DRAWING NO. 70-139

G-2	G-1	ITEM NO.	DRAWING NO.	DESCRIPTION	PROJECT NO.	USED ON ASS'Y
TOLERANCES UNLESS OTHERWISE SPECIFIED						
DECIMAL		± .005				
FRACTIONAL		± 1/64"				
ANGULAR		± 1/2°				
BREAK ALL SHARP EDGES REMOVE ALL BURRS						
APPROVED			DATE	FINISH & SPECIFICATION	TITLE	
DRAWN <i>[Signature]</i>			12-21-59	MATERIAL & SPECIFICATION	STORAGE RACKS FOR FINISHED PINS	
CHECKED						
APPROVED <i>N. Weiss</i>			12-28-59			
ENGELHARD INDUSTRIES, INC. D. E. MAKEPEACE DIVISION ATTLEBORO, MASS.				SCALE NONE	SIZE C	DRAWING NO. 50034 REV. A

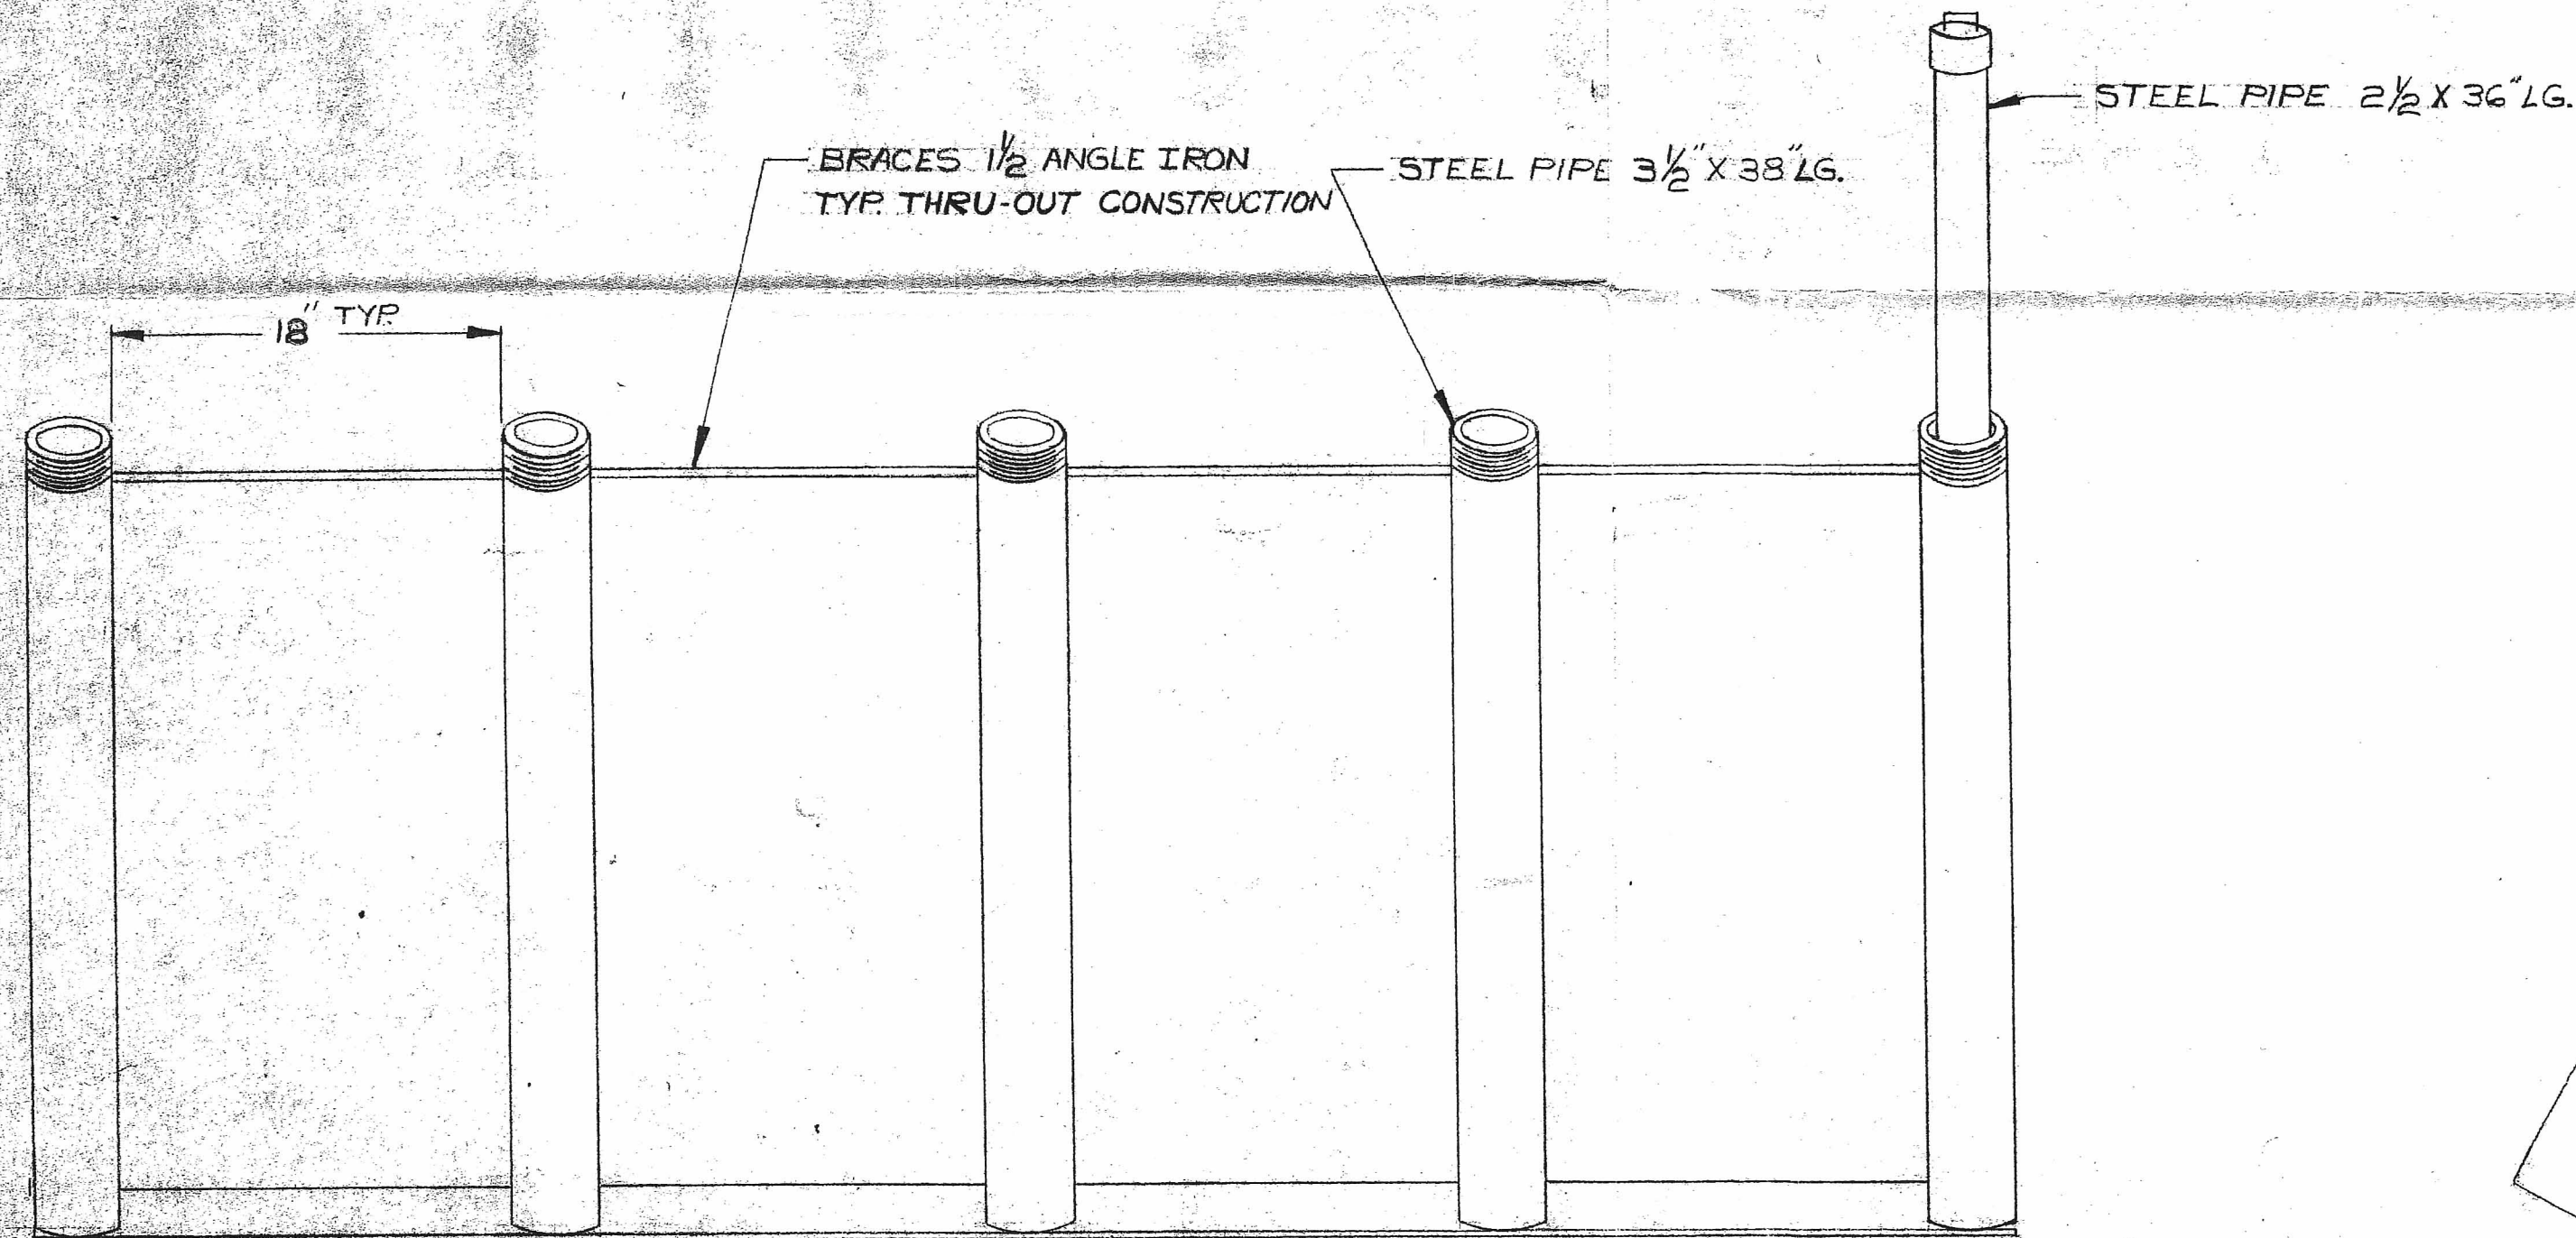
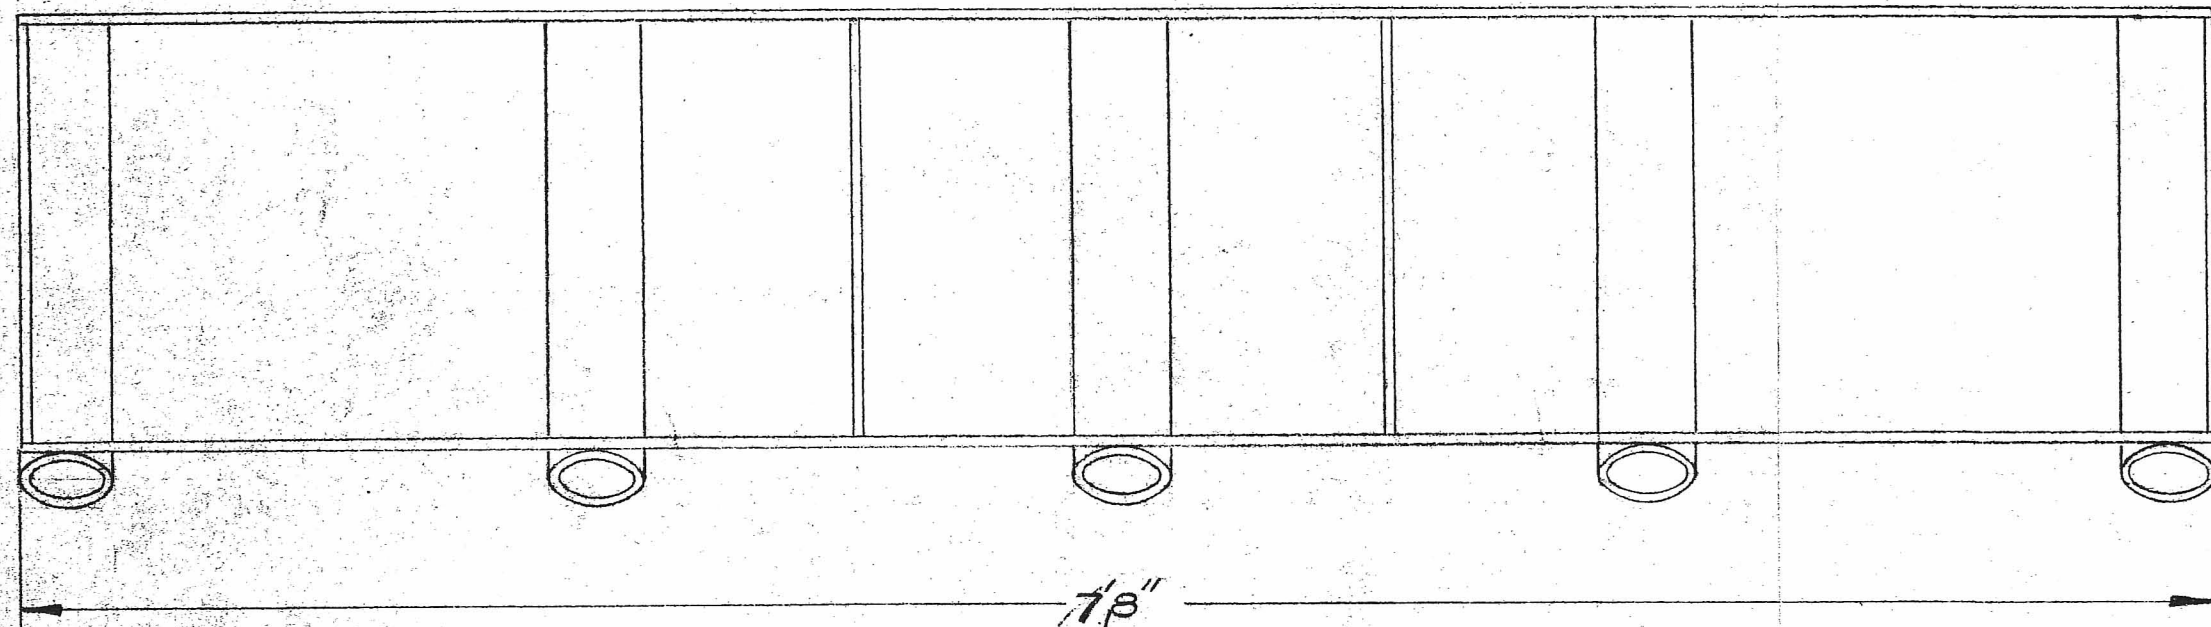
CHG. LET.	DESCRIPTION	DATE	BY	APP.	CHG. NO.
A	REMOVED CADMIUM LINER CHANGE TUBE SPACING TO 12" CHANGE BRACE FOR FLOOR MOUNTING	3/10/60	AJF		147
